# BROOKHAVEN NATIONAL LABORATORY

## MAGNET DIVISION NOTES

**Author:** R. Gupta and P. A. Thompson  
**Date:** March 19, 1993  
**No:** 491-16 (RHIC-MD-195)  
**Task Force:** RHIC  
**Title:** Upgrading QRB005 through QRB012 to Accelerator Quality Quadrupoles

# Upgrading QRB005 through QRB012 to Accelerator Quality Quadrupoles

Figure 1: Shims to be used in the proposed re-built of the RHIC arc quadrupoles QRB005 through QRB012.

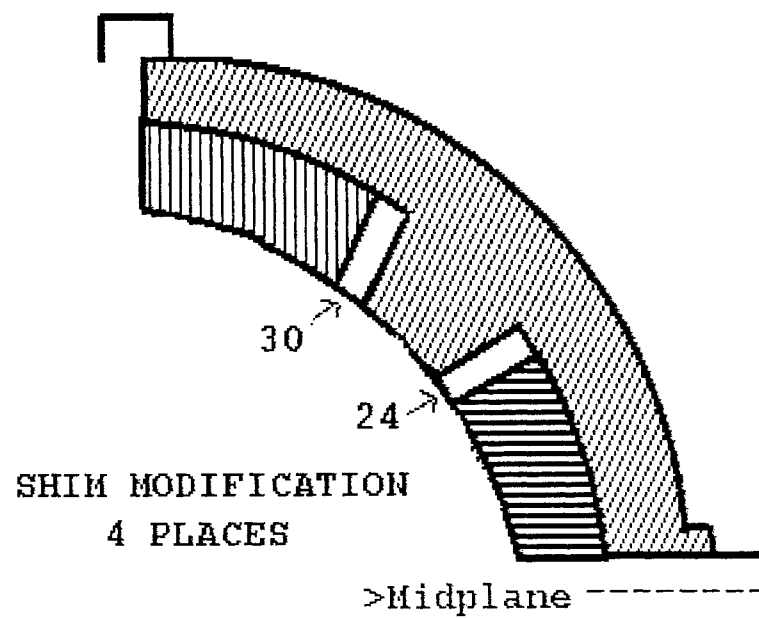
In QRB005 through QRB012, the actual shim used at all eight pole faces was 0.029". (This includes a 10 mil shim due to machining of the pole). We suggest, that these magnets be rebuilt with the new values of pole shims given here. As shown in figure 1, the four thin shims of 0.024" go on the midplane side of the four poles and the four thick shims of 0.030" go on the 90° side of the poles. The pole turns are thus effectively moved 0.003" towards the 90° side of the pole. This would bring the measured  $b_3$  close to zero. Moreover, the overall size of the coil will grow by 0.002" since the average size of the pole shim is now 0.027" instead of 0.029". This would bring the integral  $b_5$  at 1450 Amp (30GeV) close to zero in the up-ramp.
